MEMORANDUM

DATE: November 30, 2020 **RE:** 8641

SUBJECT: Response to Traffic Advisory Committee Comments
Proposed Retail Marijuana Dispensary
21 Broadway, Arlington, Massachusetts

Figure 6R

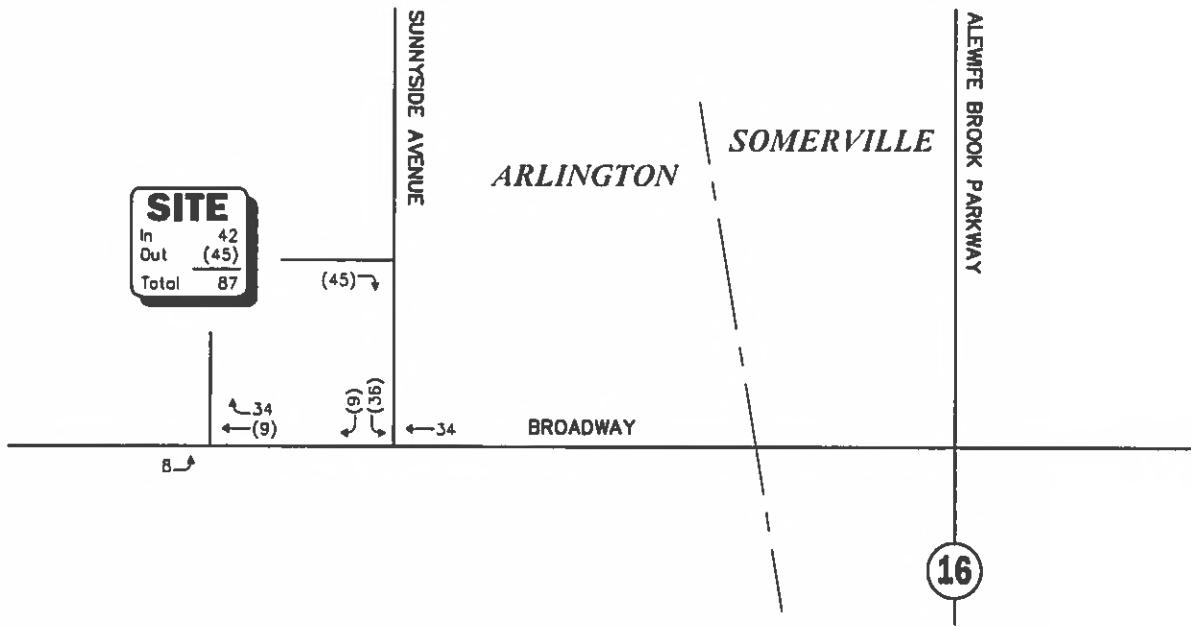
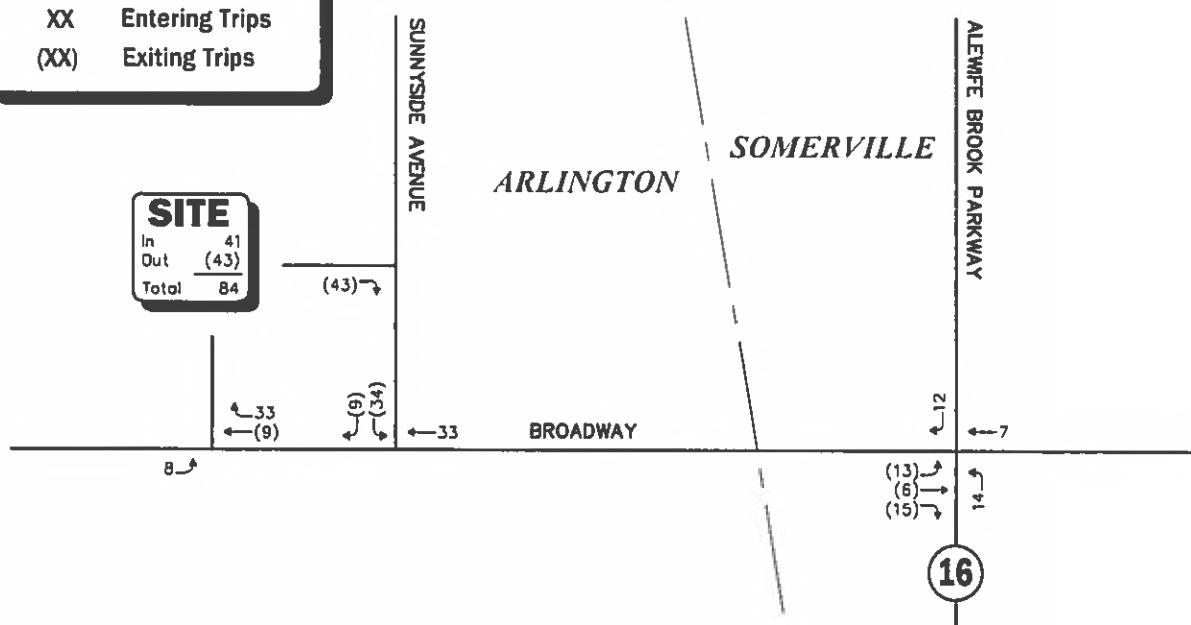
Comment: *On Figure 7, it does not appear that all the projected project-generated trips have been added correctly to the No-Build trips. The Build trips should be recalculated and the intersection level of service analysis rerun with the correct volumes. The Build volumes may also need to be recalculated based on the issue described above regarding use of the ITE trip generation rates. The conclusions of the report should be modified as appropriate based on the reanalysis.*

Response: The volumes shown on Figure 7 of the July 2020 TIA have been confirmed. In brief, those volumes were created by first removing the volumes expected to be generated by the backfill of the existing bank on site (Presented on Figure A-5) and then incorporating the volumes expected to be generated by the Project (Figures 6 and 6R) from the No Build volumes (Figure 4).
